**STAFF REPORT:** 06/11/2025

**APPLICATION NUMBER:** HDC2025-00154

**ADDRESS:** 4282/4284 WAVERLY

**SCOPE:** REPLACE WINDOWS, ADD WINDOWS TO EXTERIOR OF EXISTING WINDOW, INSTALL WINDOWS WHERE CURRENT WINDOWS ARE MISSING

#### Casements with Leaded Glass Analysis Pt. 1

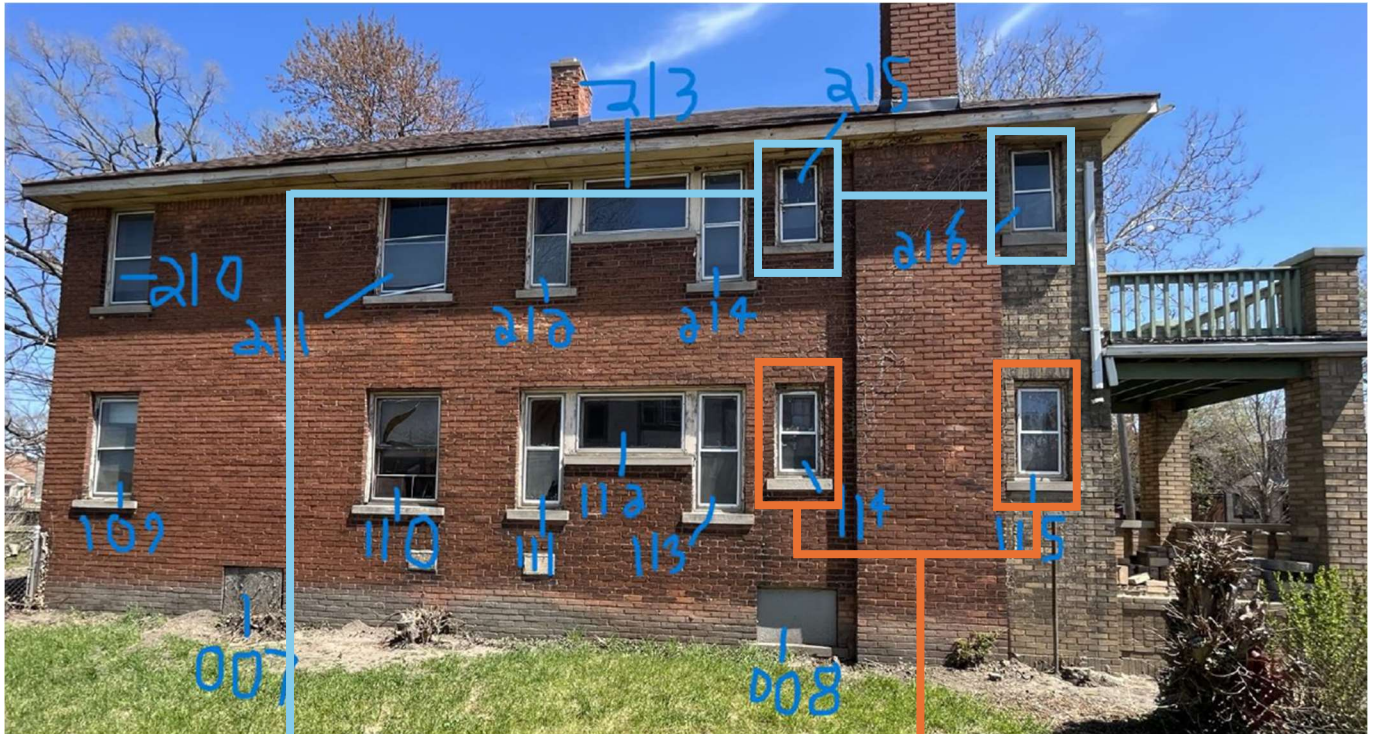
- The applicant states that there currently are no windows on the second floor flanking the fireplace, but as shown in an attic photo from the property owner's website, the historic wood leaded glass casements seem to still exist, though not currently installed.

### Casements with 9-Lite Analysis

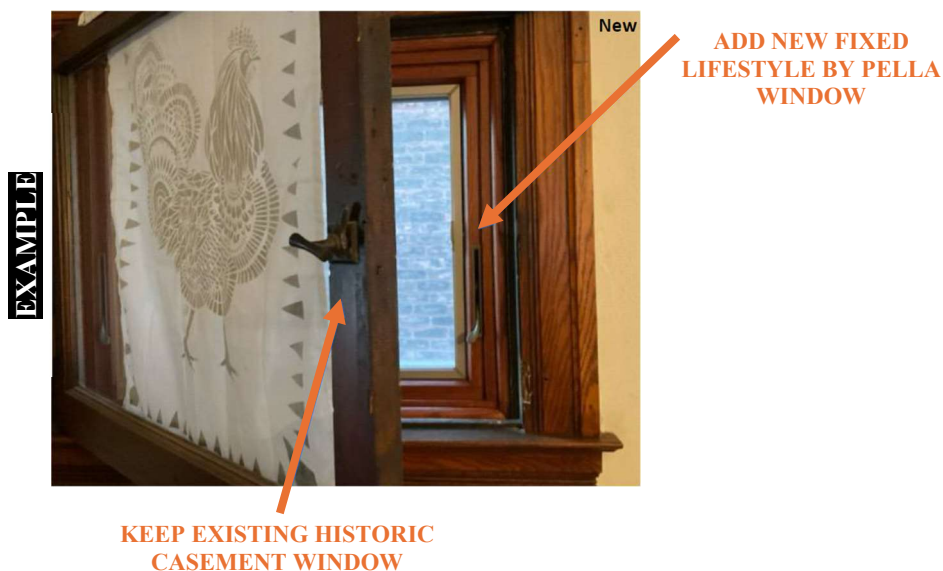
- It is staff's opinion that the right casement window is beyond repair. To preserve the visual and architectural continuity of the paired casements, it is recommended that the right casement be replicated and the left casement be restored. If the left casement is proven to be beyond feasible repair, staff recommends replacement casements simulate the 9-lite division of the historic windows.

- If window #301 (and thus #302) proves to be beyond feasible repair, subject to staff approval, replacement aluminum clad casement windows with 9-lite configuration is allowed.
